**DEPARTMENT OF THE ARMY
WILMINGTON DISTRICT, CORPS OF ENGINEERS**

Action ID No. 1993-02466

Reference the Department of the Army (DA) individual permit (IP) Action SAW-1993-02466, issued April 18, 2019 to construct a new US 70 bypass of Havelock, North Carolina in Craven County, North Carolina.

Subject: Modification of 401 Water Quality Certification Pursuant to Section 401 of the Federal Clean Water Act and Neuse Buffer Authorization with ADDITIONAL CONDITIONS for the proposed construction of the Havelock Bypass in Craven County, TIP R-1015.
NCDWR Project No. 20181598 v.2

**PERMIT DRAWING
SHEET 17 OF 167**

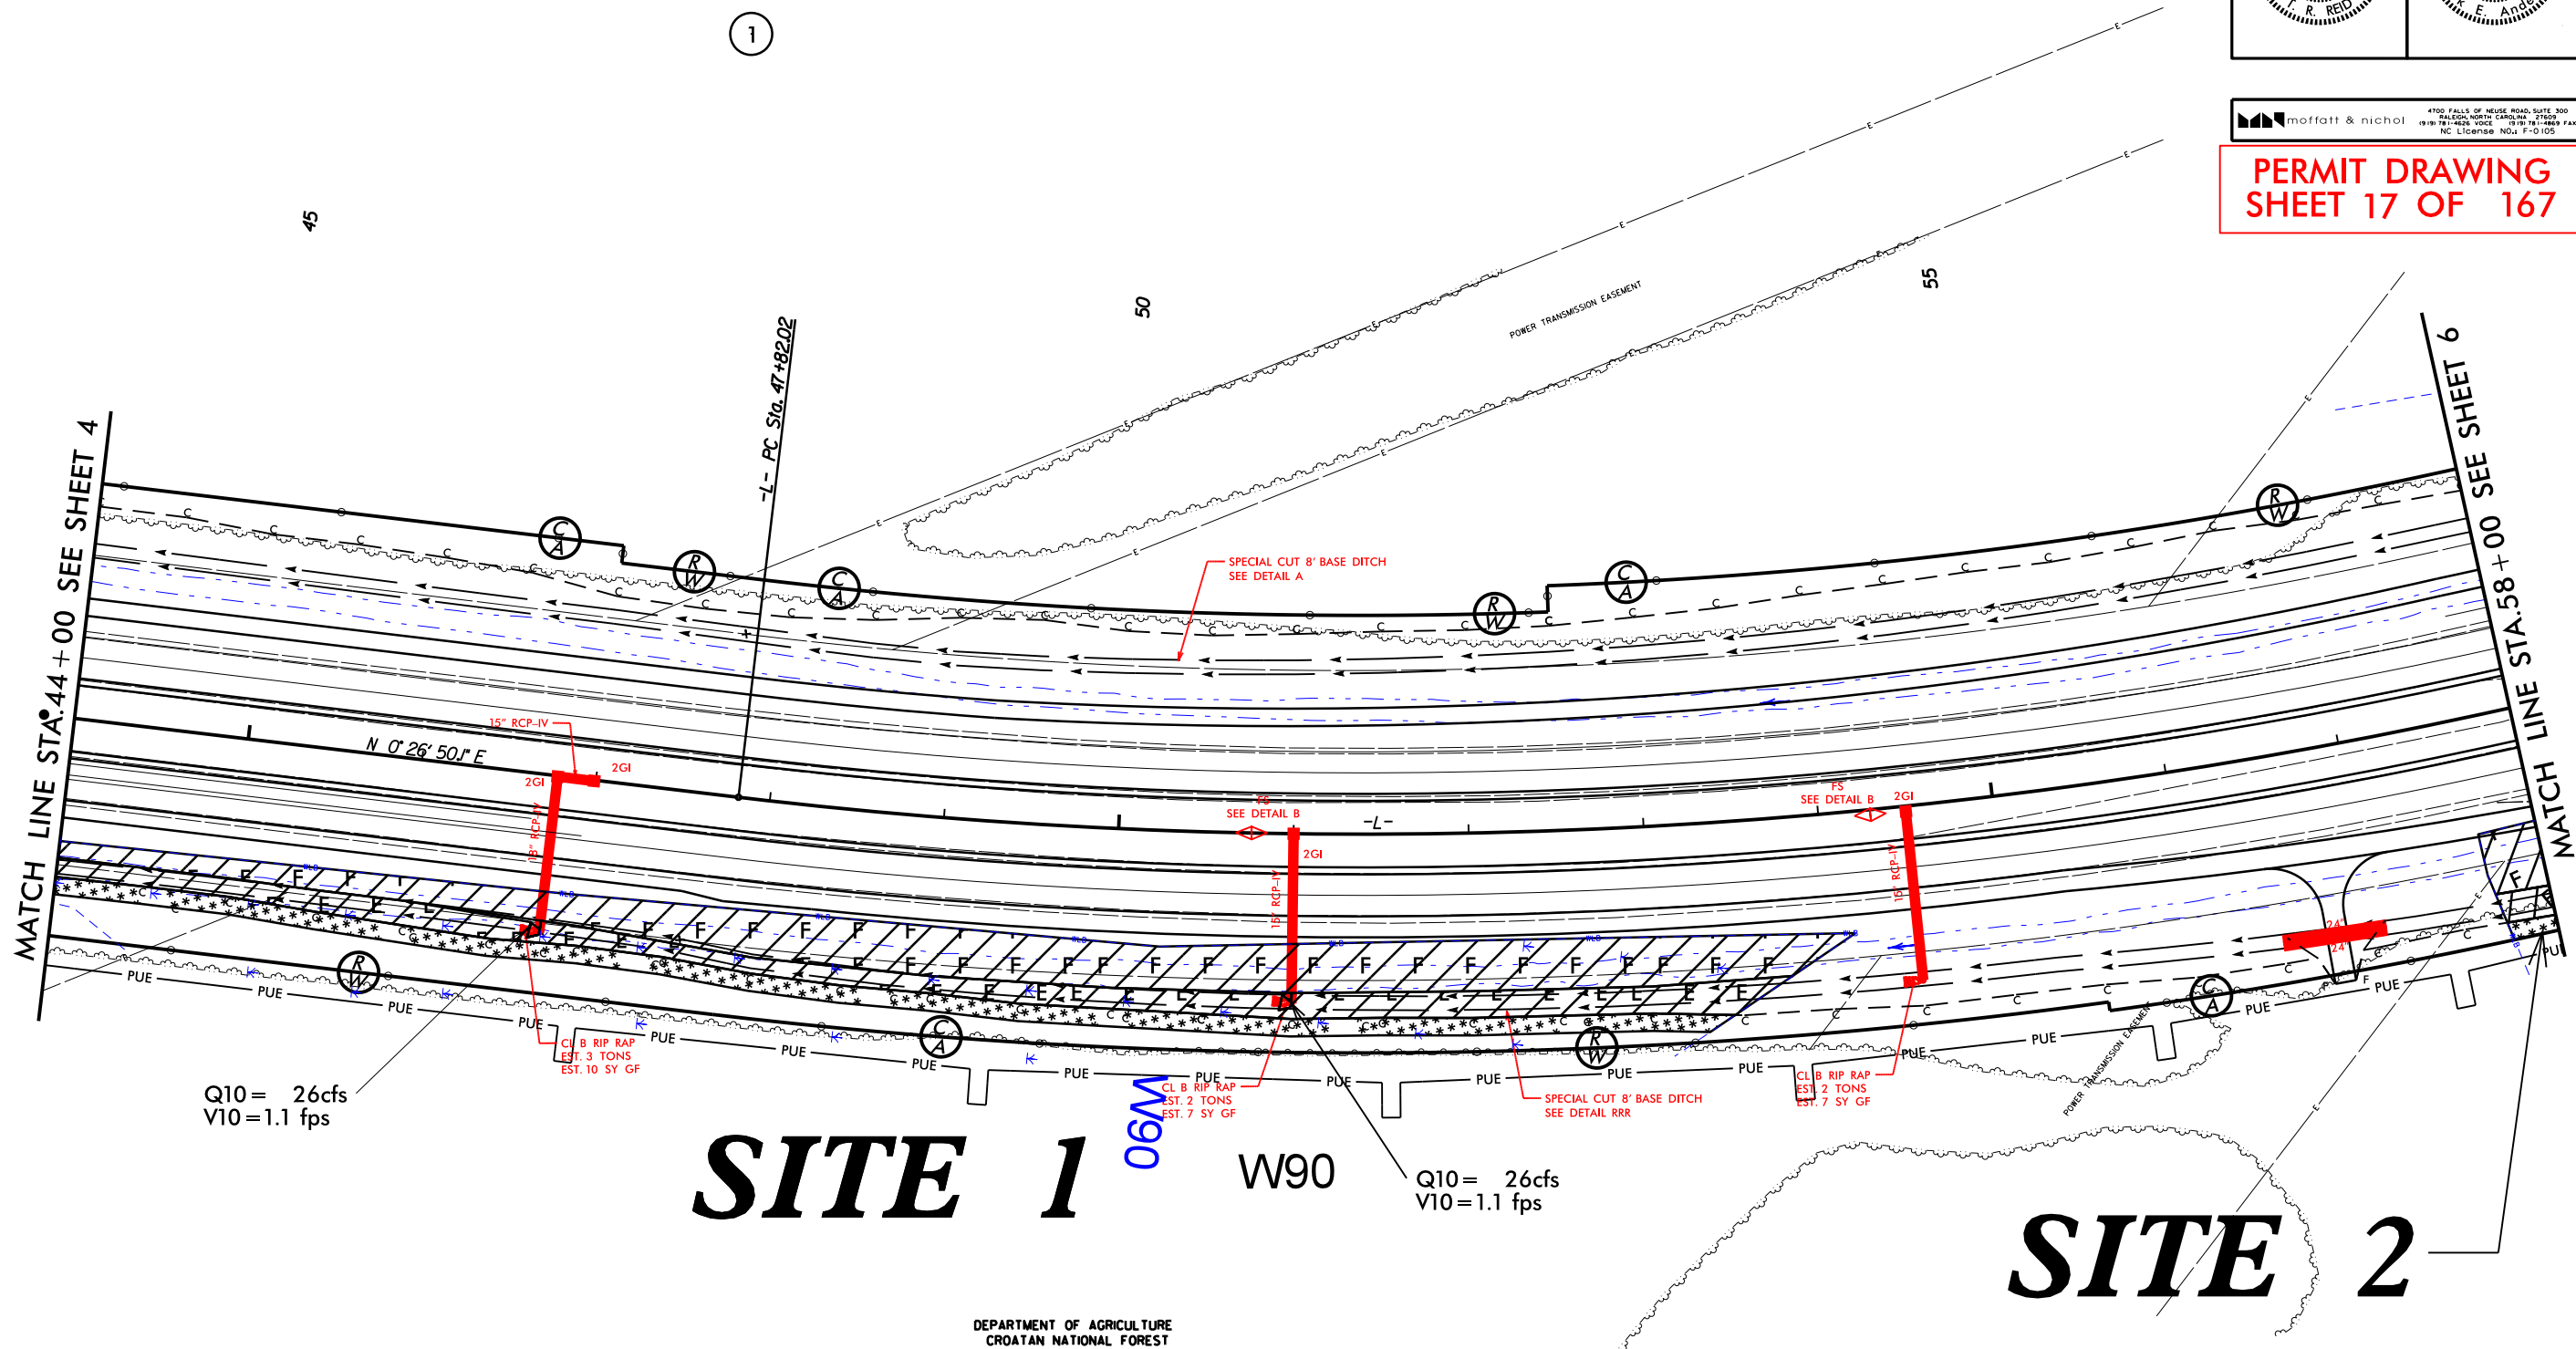
- Detail sheets updated (permit drawings 2 & 3)
- Site 1 (permit sheets 17&18) added riprap in the excavation area due to riprap pads at two pipes. A driveway was added, which did increase the impacts from fill, but decreased the mechanized clearing and excavation. The permitted total (1.16 acre) did not change.

PERMIT DRAWING
SHEET 124 OF 167

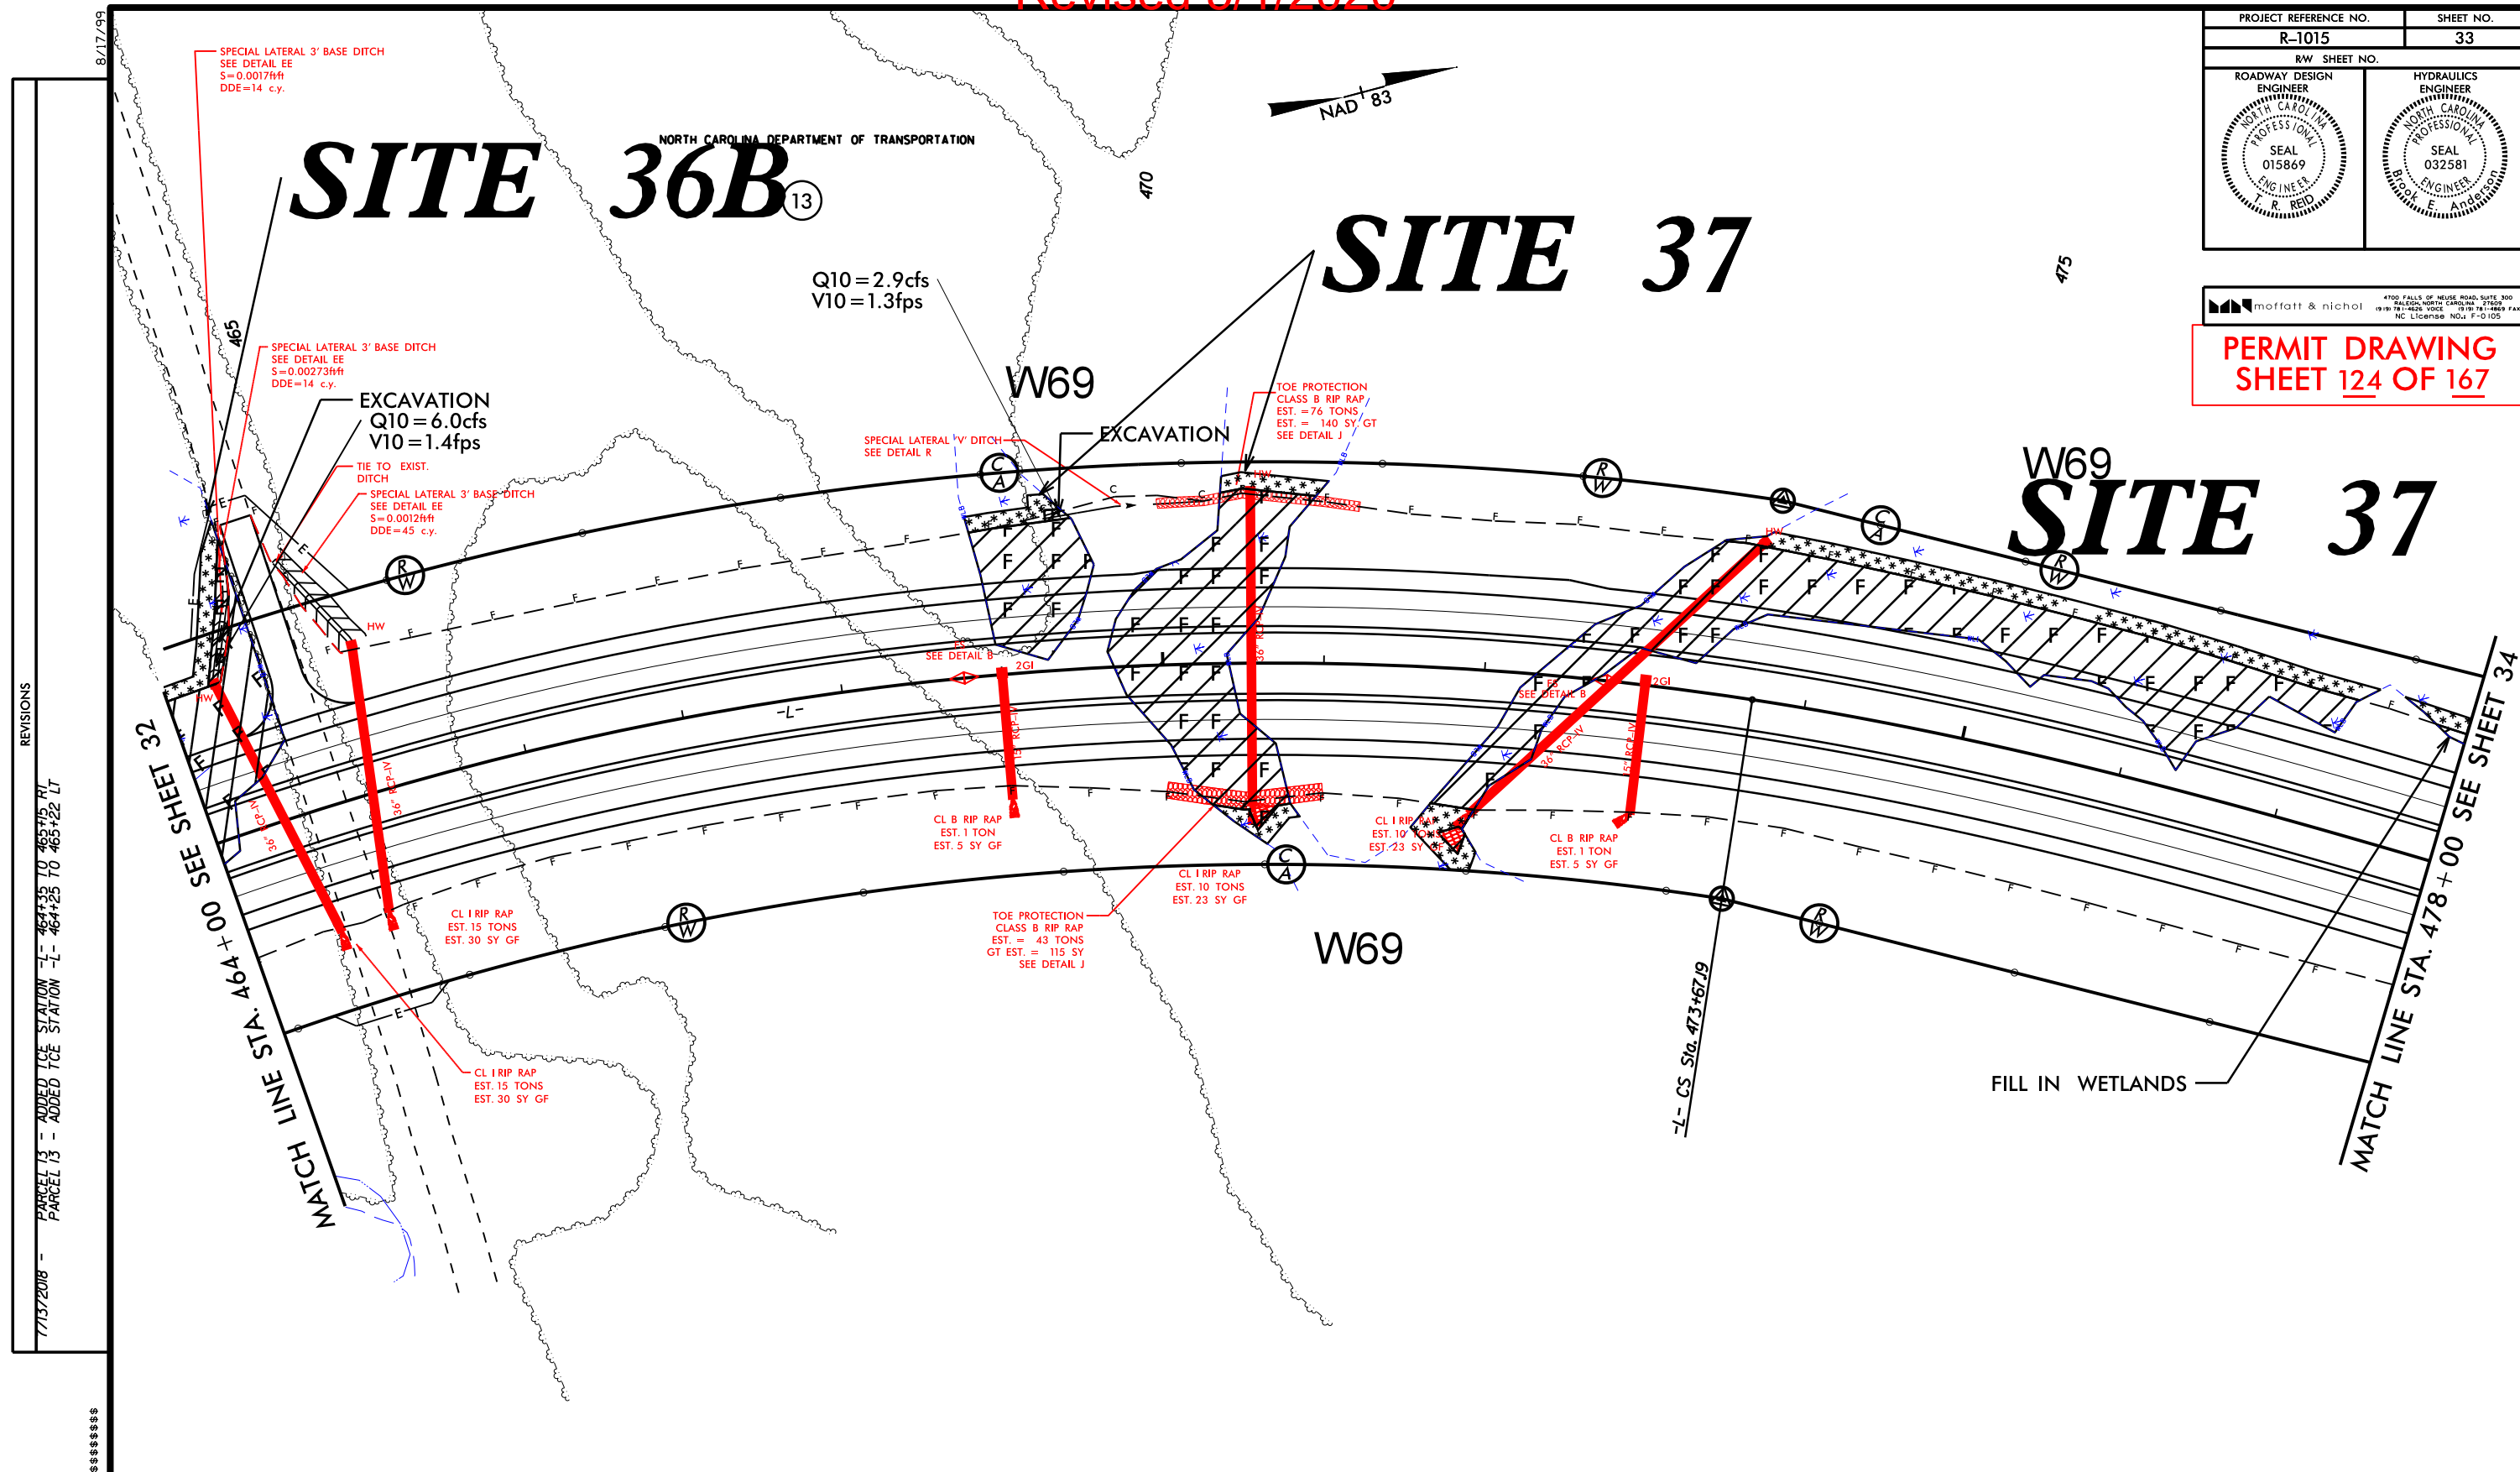
- Update to permit sheets 124 & 125. Changes were outside of impacted areas
- Update to permit sheets 130 & 131. Changes were outside of impacted areas
- Site 47, (permit sheets 142 & 143) pipe shortened to eliminate easement on property, HW added. "Temporary Impacts in Surface Water" reduced by 0.01 ac. " Existing Channel Impacts Temp." reduced by 10' .

PERMIT DRAWING
SHEET 148 OF 167

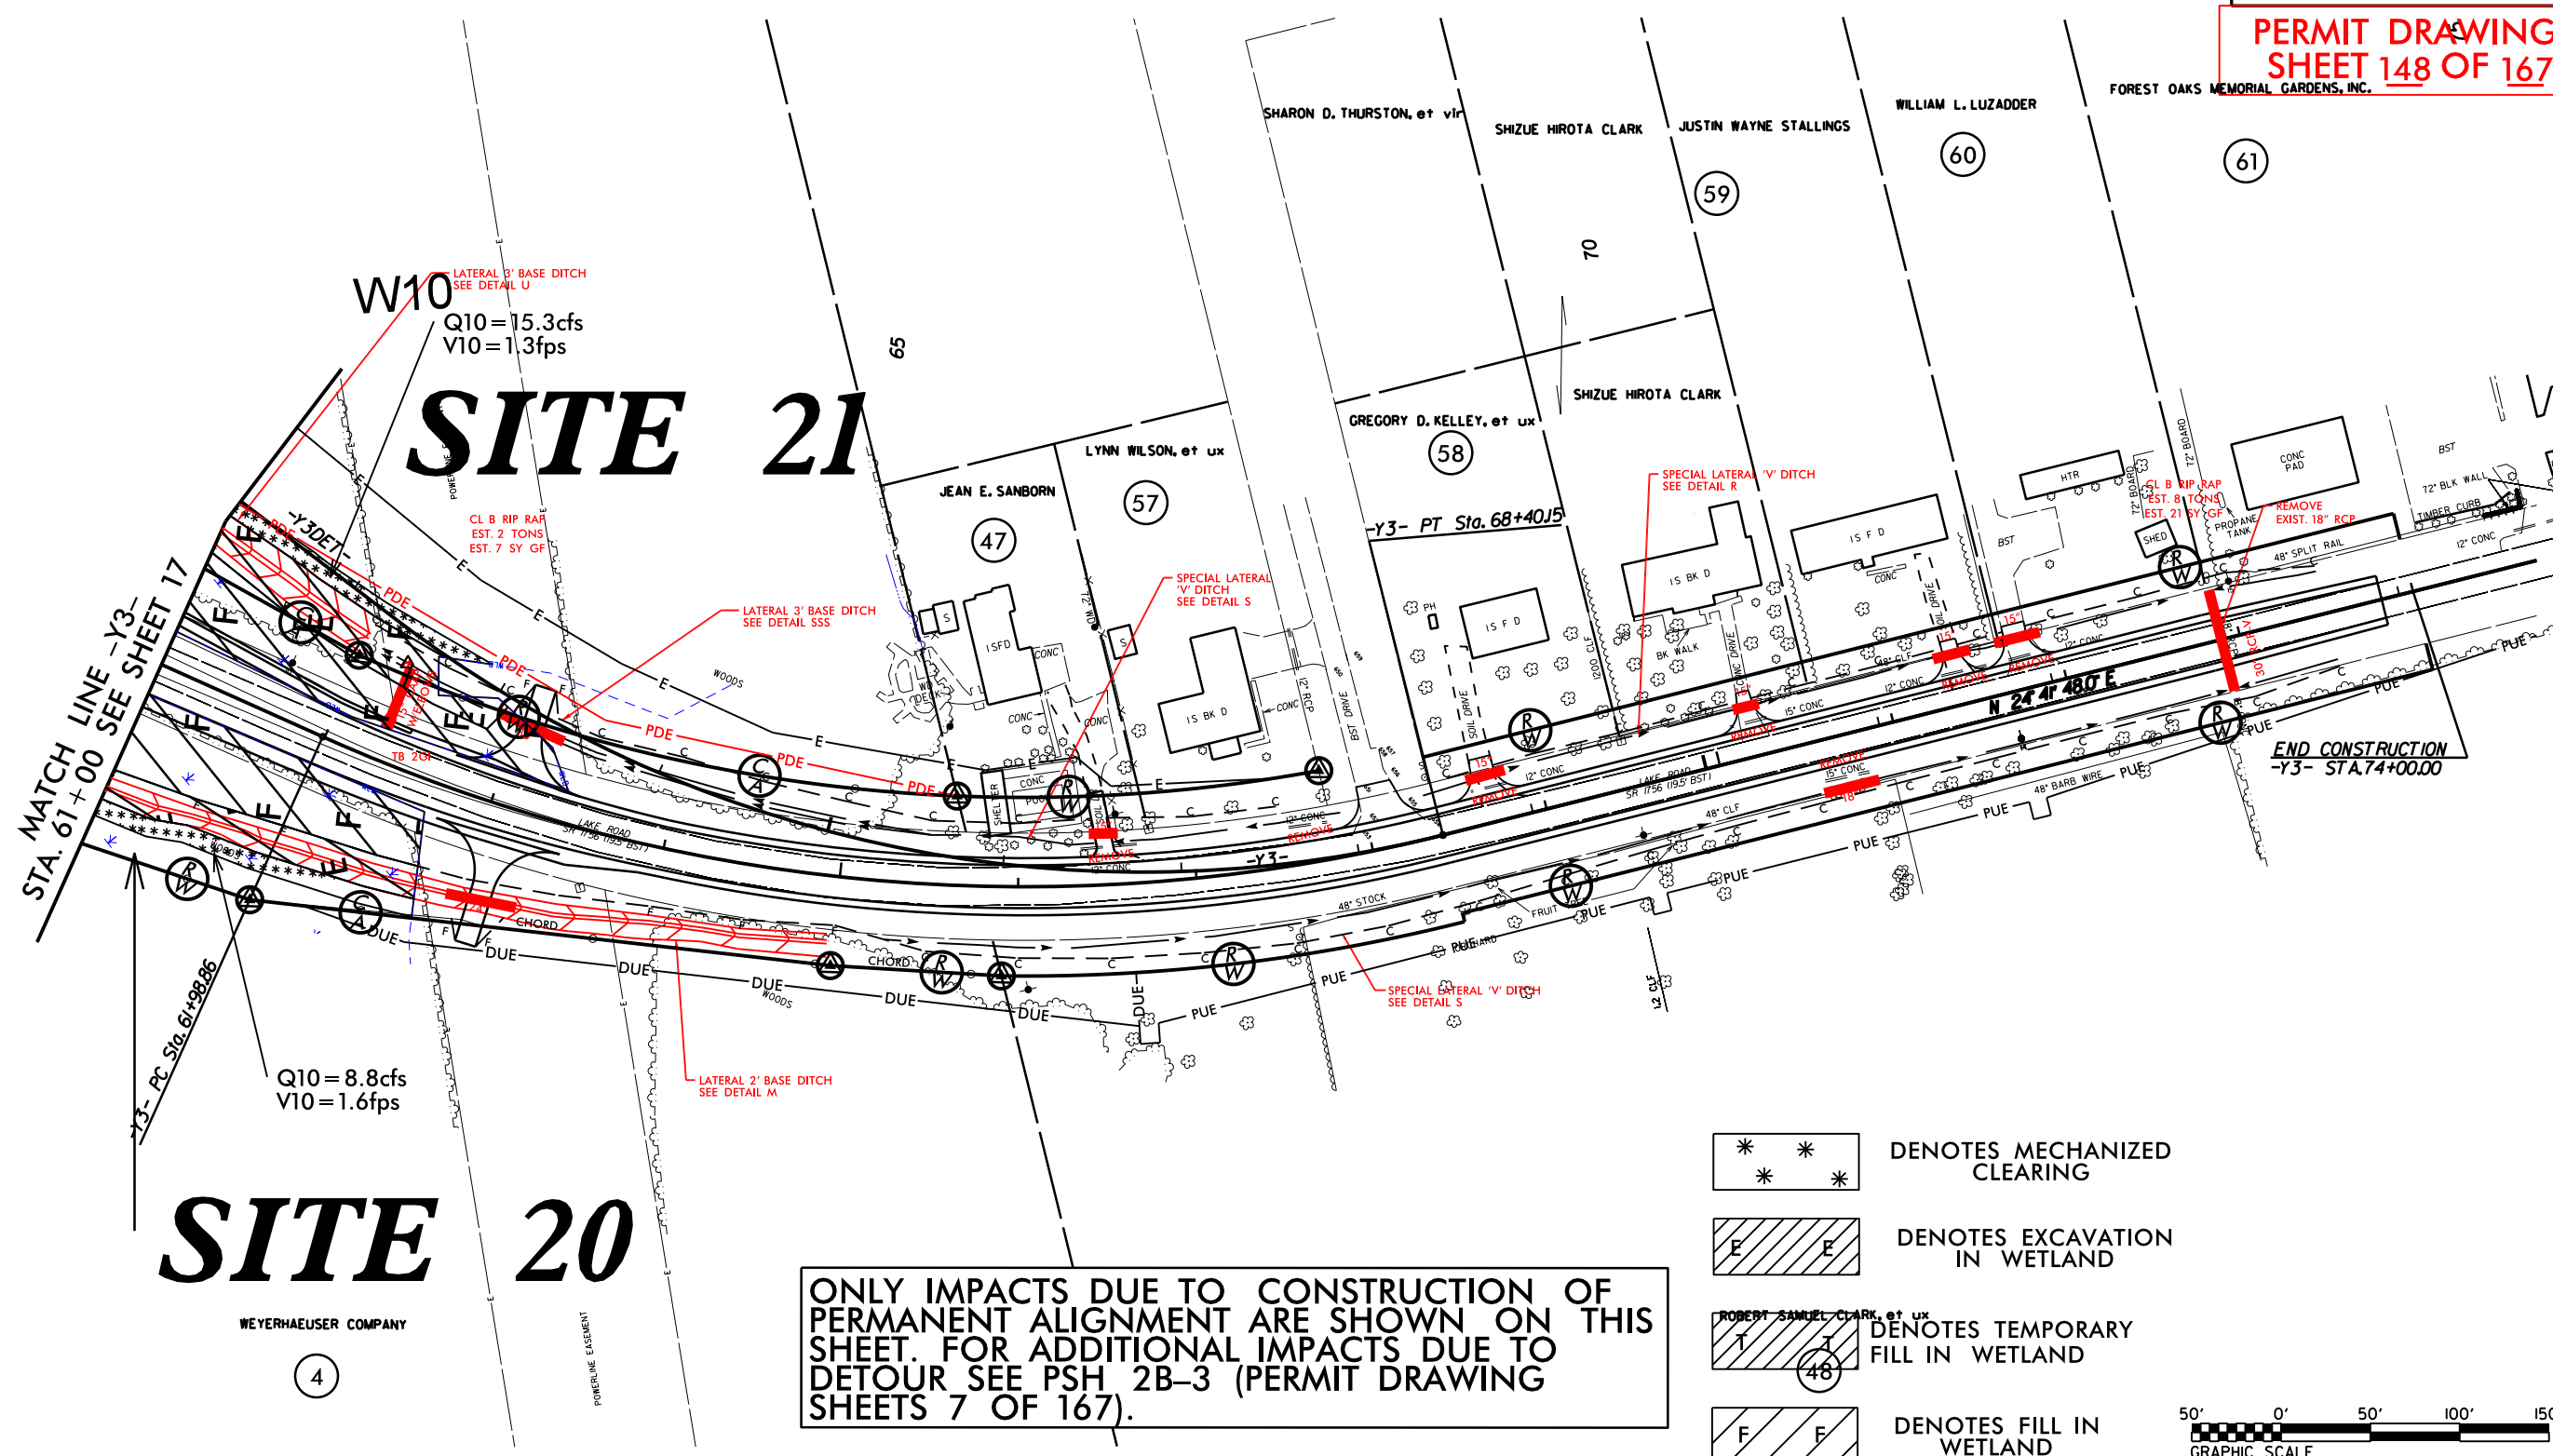
- Site 21 (permit sheets 148 &149) pipe outlet shifted. Fill increased, excavation decreased, no change to total impacts permitted for site (0.85 acre).
